JOHN RICHARDSON FAMILY **DIVISION SUBDIVISION**

APPLICATION NUMBER 10 DATE January 15, 2015

APPLICANT John Richardson Family Division Subdivision

REQUEST Subdivision

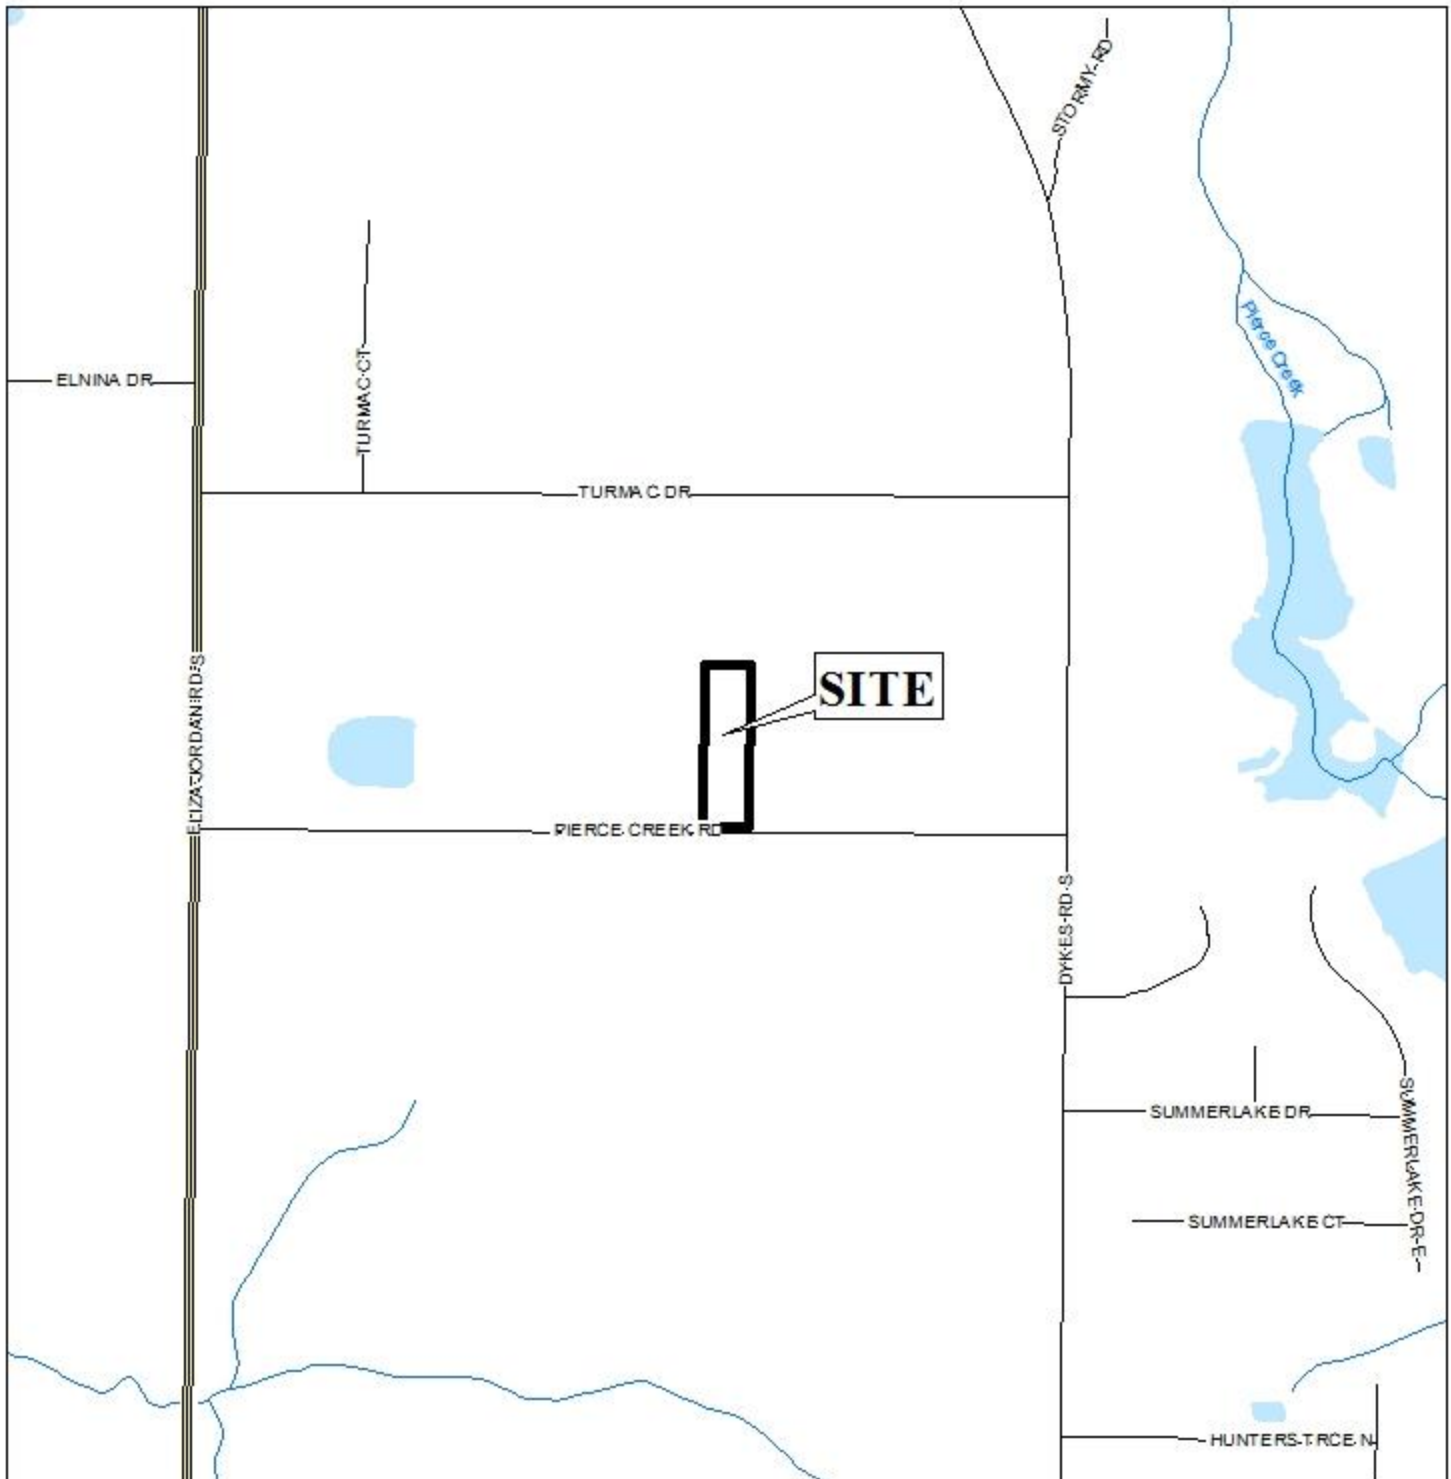
The plat illustrates the proposed 1-lot, 1.5± acre subdivision which is located at the North side of Pierce Creek Road, 780'± West of Dykes Road South, within the planning jurisdiction. The applicant states that the subdivision is served by county water and sewer. The purpose of this application is to create a legal lot of record from a single metes-and-bounds parcel. The property is developed with a single family residence.

The subject parcel was created in 2000, and there was an application for a 2-lot subdivision in 2000, that was approved in 2001, but not recorded. Therefore, the adjacent property should be included, or a letter should be submitted from the adjacent property owner stating that they do not wish to participate in the subdivision.

The proposed lot size is provided in square feet and acres, and would exceed the minimum required lot size in Section V.D.2. of the Subdivision Regulations. This information should be retained on the Final Plat, if approved.

It should be noted that the proposed Lot 1 does not meet the standards for width-to-depth ratio. Section V.D.3. of the Subdivision Regulations states that lot depth should not exceed 3.5 times the width of the lot at the building setback. As proposed, Lot 1 will be 134'± wide at the setback line and 485'± deep, resulting in a lot that is approximately 16' deeper than would normally be allowed. While there are no lots in the area that have been previously approved by the Planning Commission which exceed the width-to-depth ratio, because the current site is only slightly over the ratio, a waiver of Section V.D.3. may be appropriate.

The site is located on Pierce Creek Road, an unpaved minor road, is illustrated with an existing right-of-way of 60', making no dedications necessary.

The 25-foot minimum building setback is illustrated on the preliminary plat. If approved, the setback should be retained on the Final Plat.

As a means of access management, a note should be required on the Final Plat, if approved, stating that the development is limited to the existing curb cut, with the size, location and design to be approved by Mobile County Engineering and conform to AASHTO standards.

Based upon the preceding, this application is recommended denial, subject to the following conditions:

- 1) the adjacent property (Parcel #: R022705210000052.002.) should be included in the subdivision, or a letter should be submitted from the adjacent property owner stating that they do not wish to participate.
